# BCA Assessment Report

Oakdale East Industrial Estate – Precinct 2

**Revision 2**

Reference: S240313

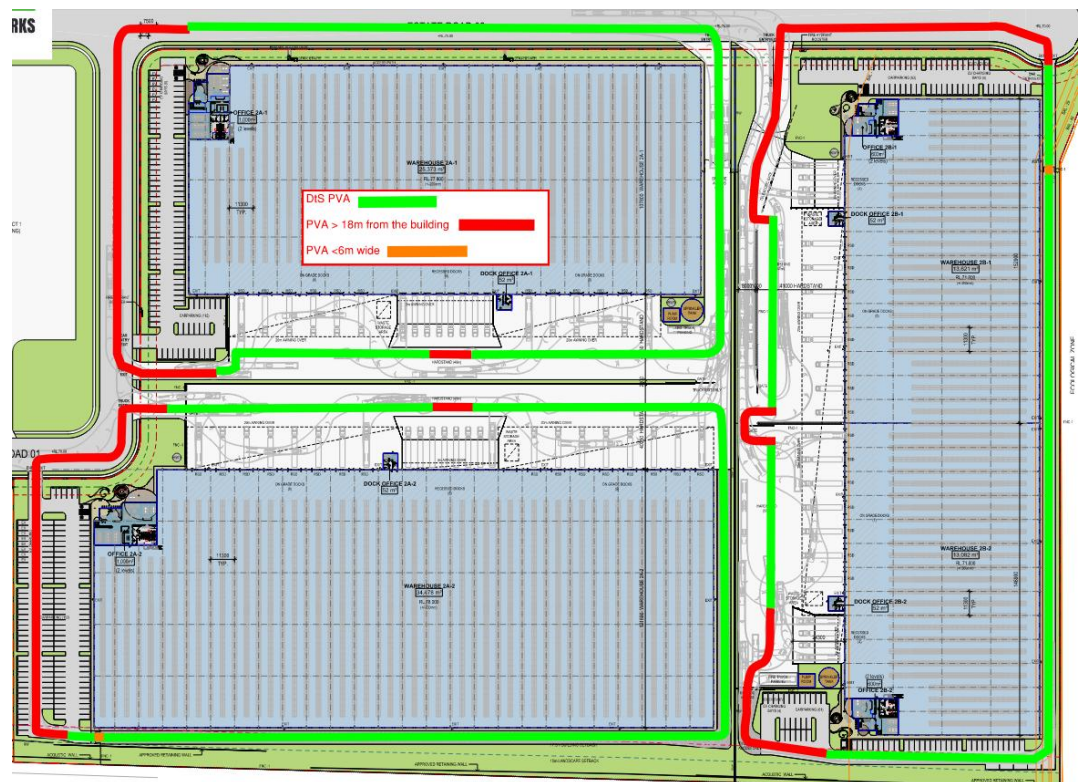
<p><b>C3D5</b></p>	<p><b>Requirements for Open Spaces and Vehicular Access:</b> Open space and vehicular access required by C3D4 must comply with the requirements of sub-clauses (a) &amp; (b) of this Part whereby they must be 6m wide within 18m of the external walls of the building and of a suitable bearing capacity and unobstructed height to permit the operation and passage of FRNSW vehicles.</p> <p><b>Comment:</b> The proposed warehouse building complies with the provisions of C3D5 except for the areas shown in red on the mark-up below. These non-compliances will be required to be</p>

addressed as a Performance Solution by the Fire Safety Engineer to demonstrate compliance with C1P9:

Warehouse 2A-1

- The vehicular access is greater than 18m from the building around the western and south-western corner of the building along Estate Road 1.
- The vehicular access is greater than 18m from the building around the recessed dock.

Warehouse 2A-2

- The vehicular access is greater than 18m from the building around the western and north-western corner of the building along Estate Road 1 and along the carpark.
- The vehicular access is greater than 18m from the building around the recessed dock.
- The perimeter vehicular access is reduced to 5m at the eastern gates of Warehouse 2A-2.

Warehouse 2B-1/2B-2

- The vehicular access is greater than 18m from the north-western, northern and south-western corner along the staff carparks and Estate Road 2.
- The perimeter vehicular access is reduced to 5m at the eastern gates of Warehouse 2B-1/2B-2.

**Note 1:** Any proposed gates are to achieve no less than 6m unobstructed width or the reduced width will need to be included in the above Performance Solution.

**Note 2:** The driveways providing vehicular perimeter access must be designed with adequate loading capacities, gradients and swept paths to accommodate a fire truck, having regard to the FRNSW Fire Safety Guideline – Access for Fire Brigade Vehicles and Firefighters.

**Note 3:** The Trial Design for the Fire Engineered Performance Solution must take into consideration and detail the proposed security access to the site and how this may impact on FRNSW vehicular access.

**Note 4:** The intertenancy gates between Warehouse 2B-1 & 2B-2 are to open on fire trip or fitted with a 003 manual override.
